**SUBJECT: Transmittal of Responses to AP1000 DSER Open Items**

# AP1000 DESIGN CERTIFICATION REVIEW

DSER Open Item Number: 15.2.7-1 Item 11

**DSEI Open Item Number: 21.5-2 Item 19 Revision 1**

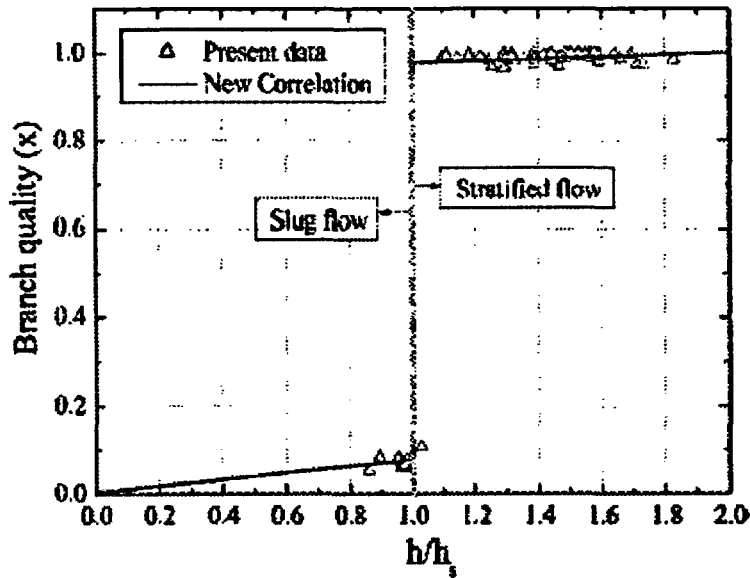
Please address the following limitations in the Westinghouse simplified model regarding the boron concentration analysis (provided in Attachment 1 to Westinghouse letter DCP/NRC1612 dated August 15, 2003):

- A. The simplified model is one-dimensional and therefore does not account for the two-dimensional radial void distribution in the hot leg, nor in the horizontal sections of the ADS-4 piping. Separated flow is not modeled in the hot leg nor the ADS-4 piping. Also, the vertical flow regime map does not apply to the horizontal section of the hot leg nor the horizontal sections of the ADS-4 piping. As such, it does not appear that the void

- B. The simplified model assumes homogeneous fluid behavior which dictates that liquid will always exit the ADS-4 piping. The model cannot simulate the collection of steam in the top portion of the hot leg piping which could become separated and chug intermittently causing step increases in boric acid content during the long term. It is not clear that intermittent chugging will flush the boric acid content from the vessel. This limitation applies to the horizontal sections of the ADS-4 piping as well.

- D. The quality out the ADS-4 line is assumed to be the same as that at the core exit (with an adjustment to account for pressure difference). This assumption is not considered valid and, with the above-mentioned limitations of one-dimensional modeling approach, cannot be verified. Since steam will collect in the top portion of the hot leg and there is a large horizontal section in the ADS-4 piping, the quality of the fluid exiting ADS-4 is not expected to be the same as that exiting the entire core region.

It is instructive to look at several off-take experiments where the impact of the upstream flow regime (in Hot Leg pipe) was considered. These are ATLATS facility at OSU [1], and one investigated by Moon and No [2]. These experiments suggest bi-modal operations depending on the upstream flow regime. While the upstream (Hot Leg) is stratified, the onset of entrainment can be adequately predicted by an existing correlation such as one suggested by Smoglie [3]. The branch quality is very high while the upstream is stratified. As the vapor flow increases, the slugging begins in the horizontal leg, and the branch quality becomes very low as a lump of liquid enters the branch line and ejected away. There is no smooth transition between the two off-take operations as seen in the figure below (Figure 10 from [2]).

The figure shows the branchline quality as a function of ratio of the distance of the liquid surface from the top,  $h$ , to the critical distance for the onset of slugging,  $h_s$ .

This behavior is expected at the ADS4 off-take. Since there is no smooth transition between the two off-take operation modes, the ADS4 pipe experiences two flow patterns of the high quality flow and the low quality flow in an oscillatory manner. On the average, the ADS4 pipe experiences the flow quality consistent with removing the core energy and gradually reducing the system pressure in a quasi-steady state manner. This is shown in OSU tests and by simulations with NOTRUMP and WCOBRA/TRAC. It is important to recognize that the two-phase discharge results from the mass, energy and momentum balances. This is shown in the simplified model analysis in the response to DSER Open Item 21.5-3.

#### Taitel-Dukler Vertical Flow Regime Map at 40 psia and Dia = 14.6 in

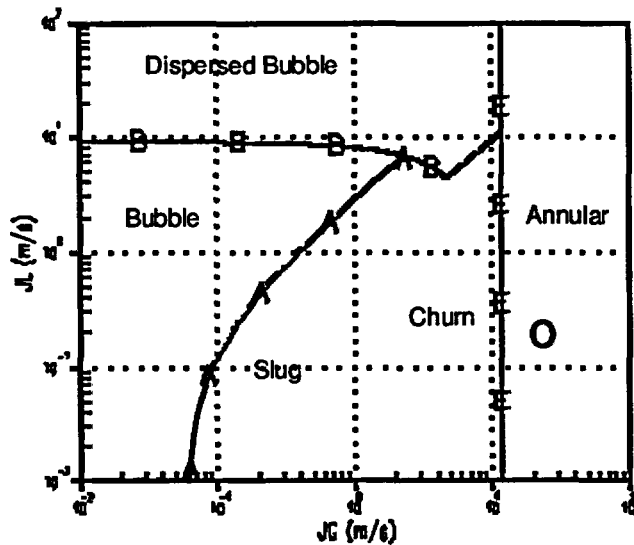
distribution and attendant flow regimes in the horizontal sections were properly determined. The resulting ADS-4 exit qualities are also questionable.

O - Operating points for 14 and 30 days after SBLOCA

The expected operating point in the ADS4 pipe at 14days and 30days after SBLOCA are compared with the Taitel-Dukler vertical flow regime map. This comparison and the Kutateladze number for these conditions shown in Table 3 and 4 indicate that ADS4 is in annular/dispersed drop flows.
